Date: September 7, 2023  
To: TRPA Hearings Officer  
From: TRPA Staff  
Subject: Single-Family Residential Rebuild for North Shore TVCA LLC,  
6650 North Lake Boulevard, Tahoe Vista, Placer County, CA; Assessor's Parcel  
Number (APN): 117-072-006; TRPA File No.: ERSP2023-0707

**Requested Action:**

**SOUTH ELEVATION**  
1/4" = 1'-0"

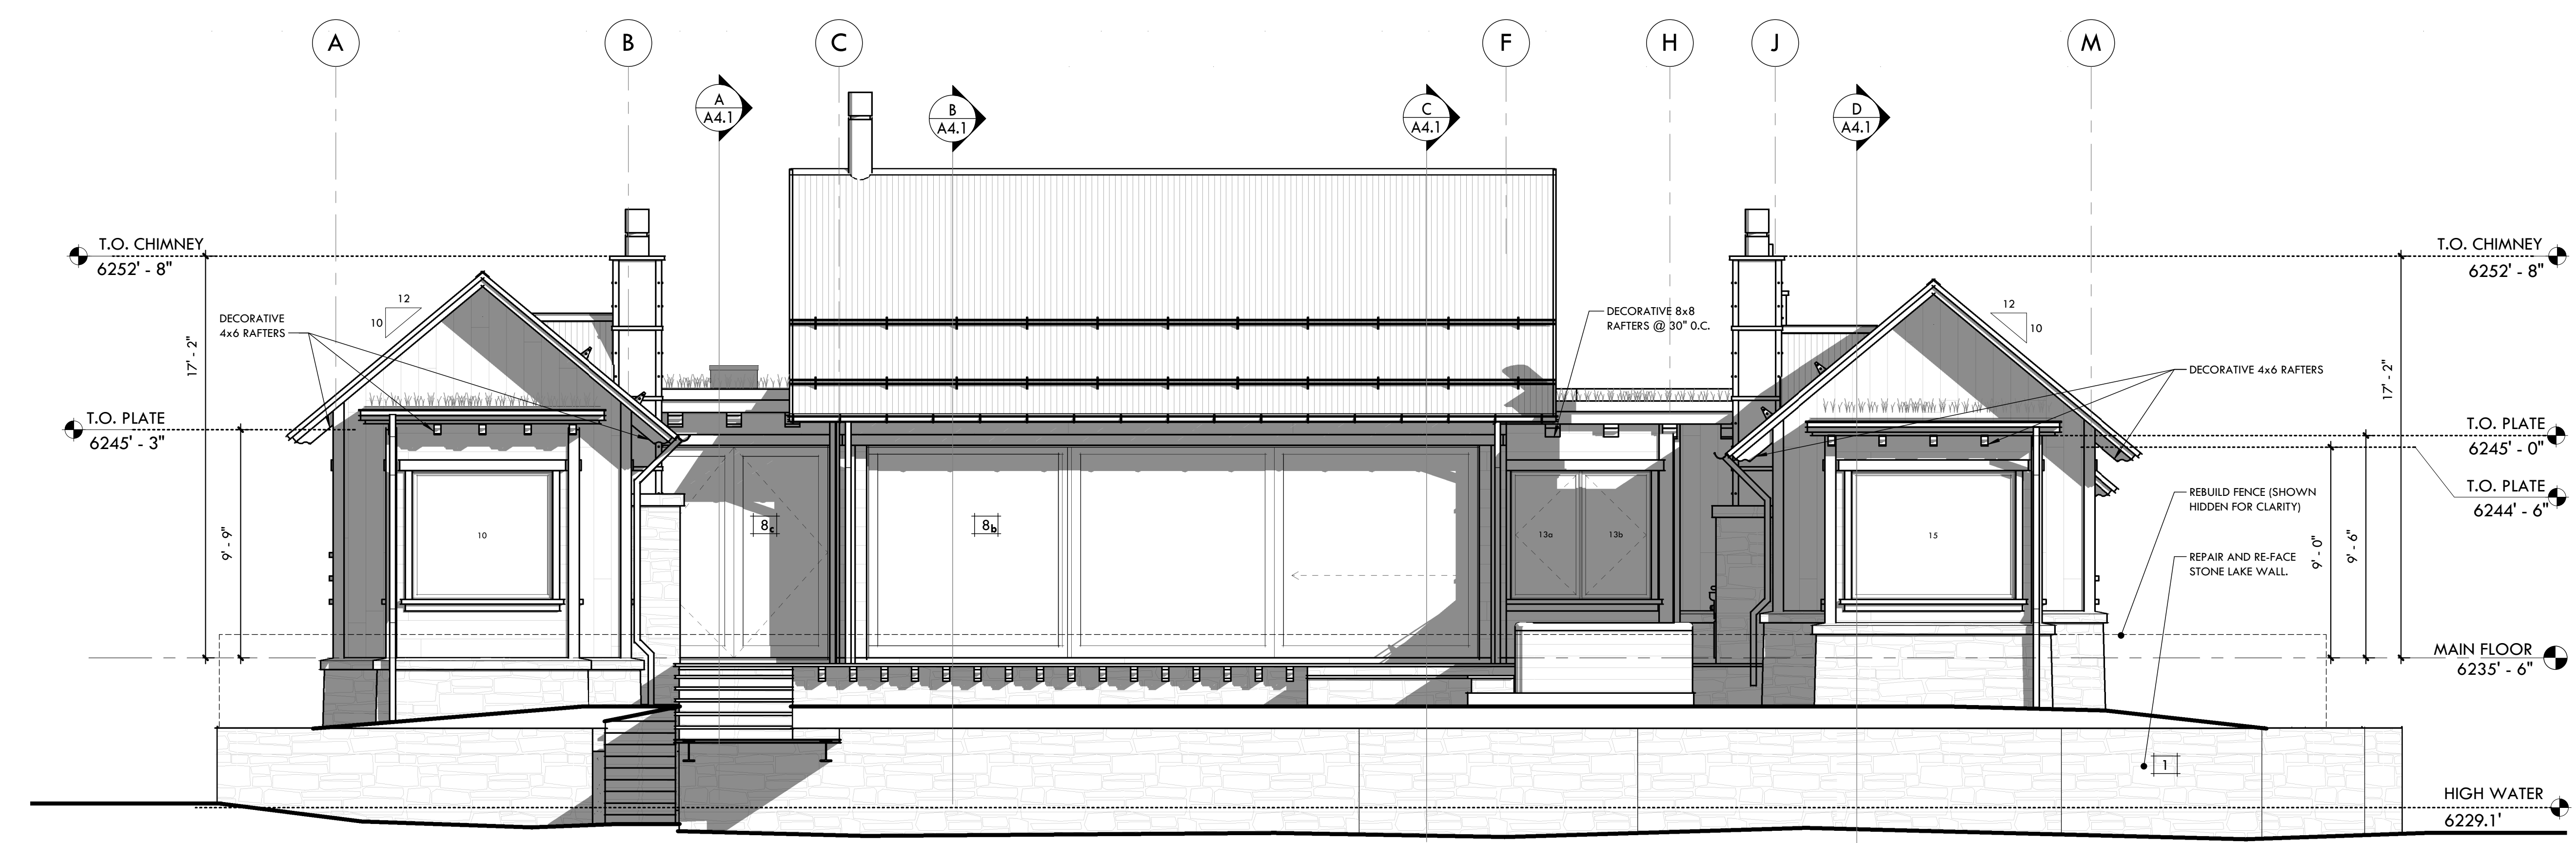
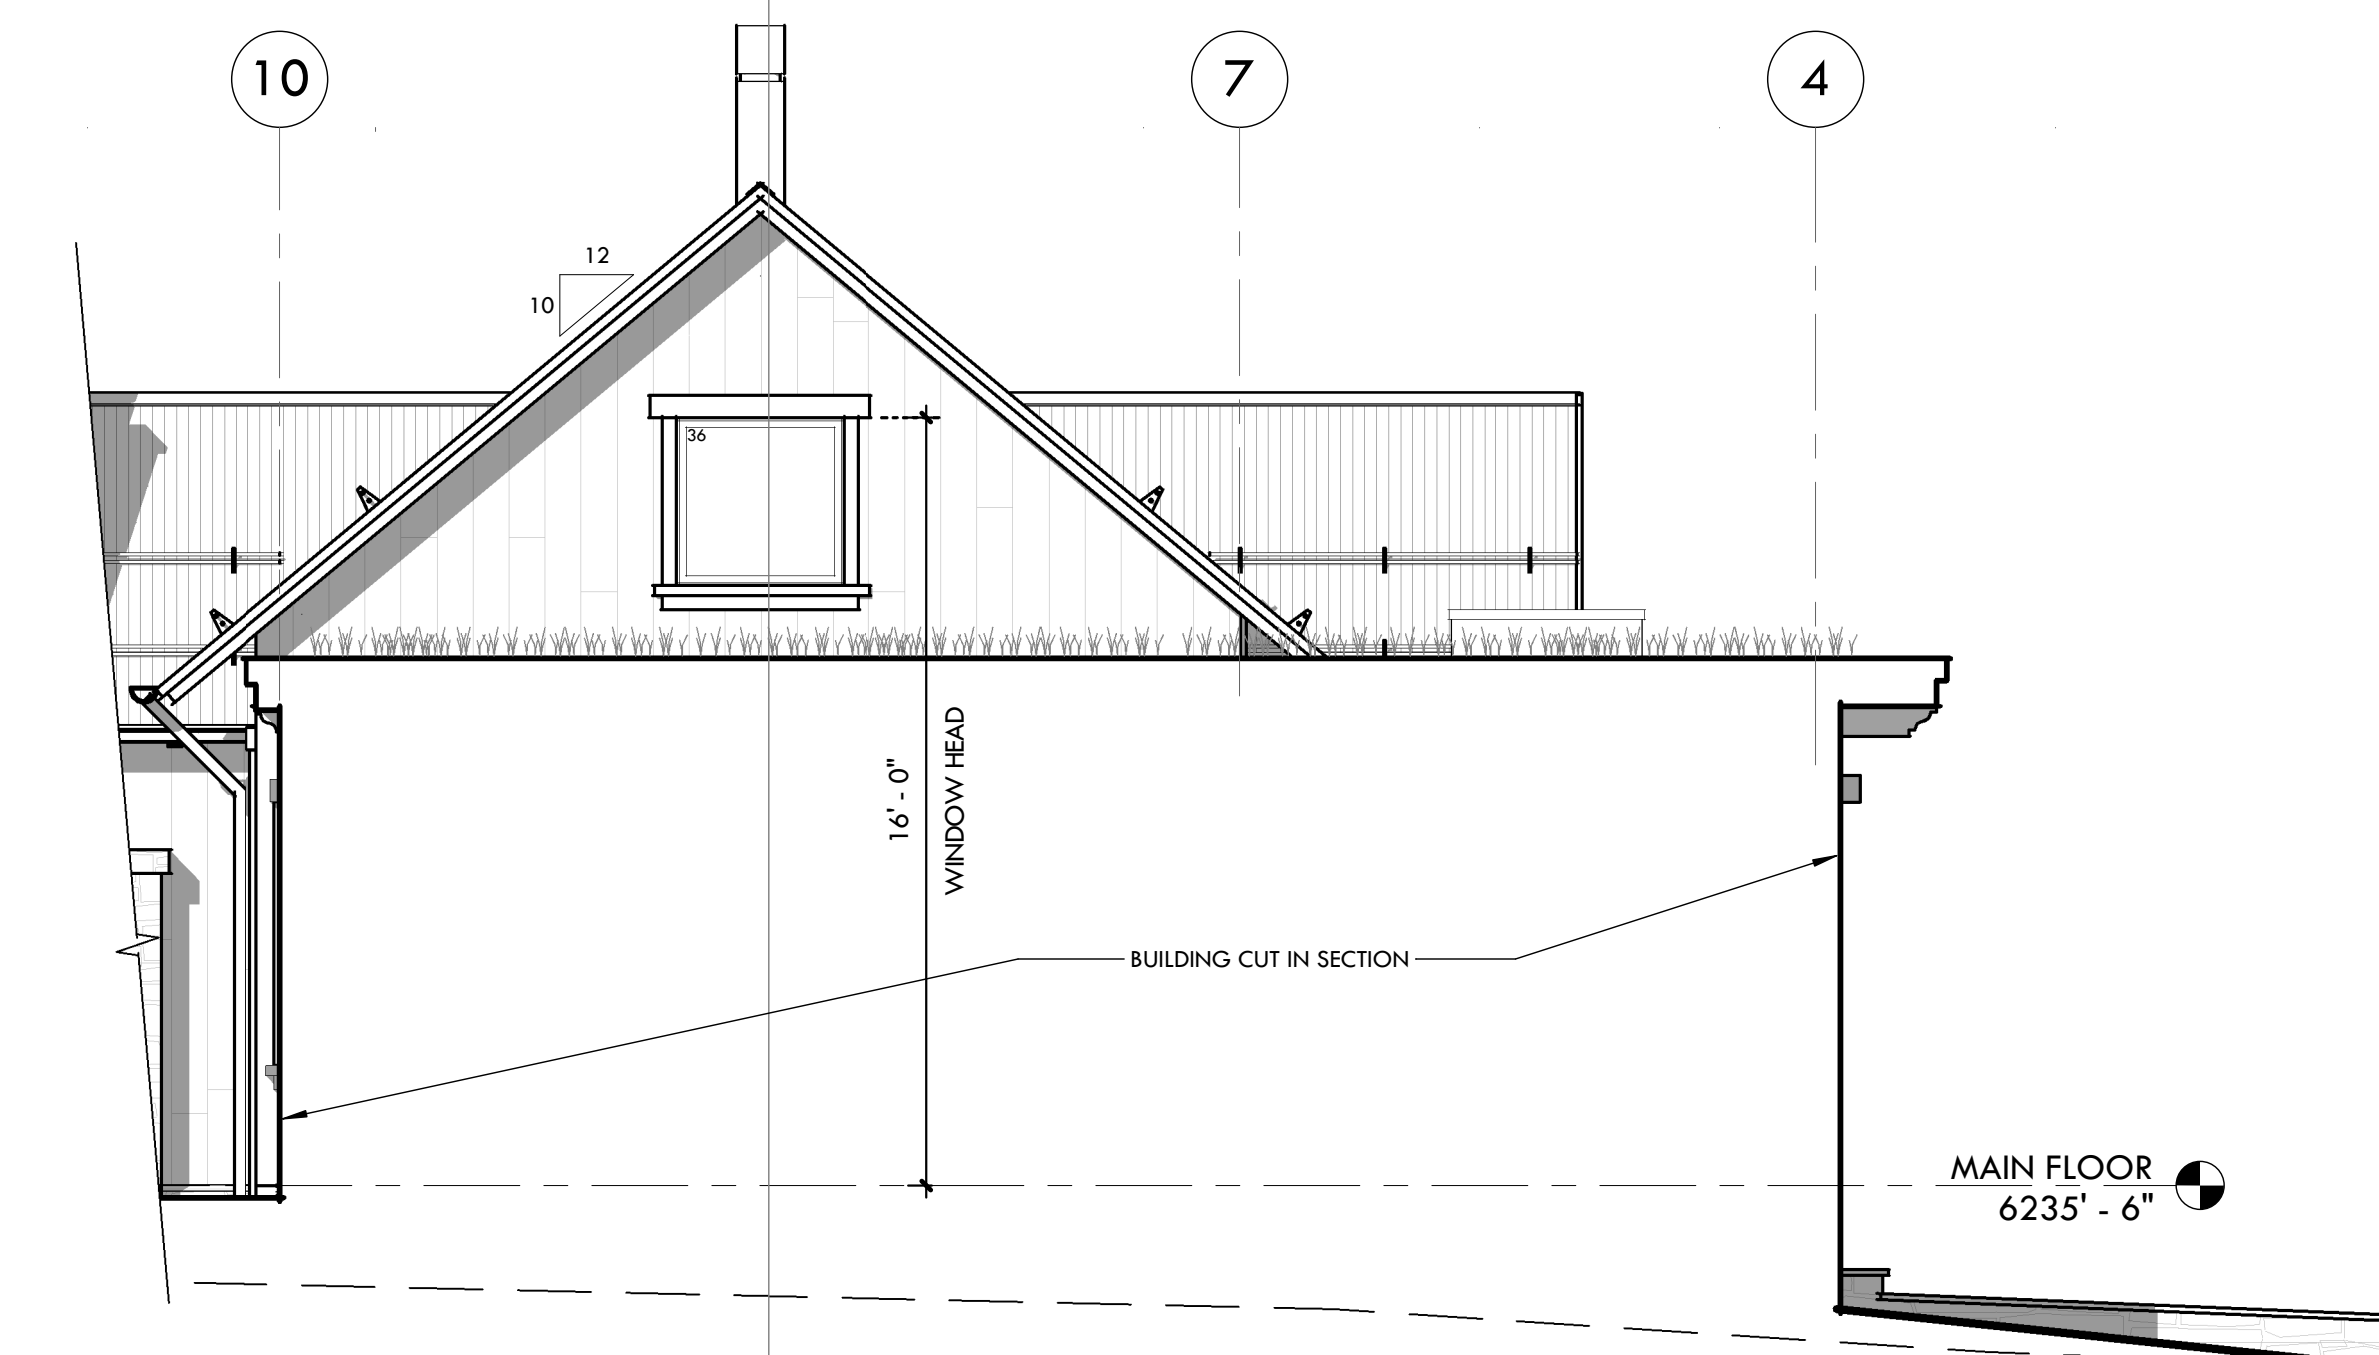
- (1) Show elevations of the bottom of foundations and support footings. Locate and label the maximum depth of excavation. Excavations shall not exceed 5 feet in depth and shall not extend below elevation 6,230,1’.

- (2) Provide additional material and color specifications for non-reflective (matte) paint or unfinished/weathering surfaces for the metal fence, metal roofing, exposed metal flashings/trim, metal chimney, and metal gutters/downspouts.

- (3) Specify 11 percent maximum reflectivity for the south elevation windows.
  - (4) Add notes on the garage and utility shed elevation sheets “Materials and colors for accessory buildings shall match materials and colors for the main house (see sheet A3.1).”
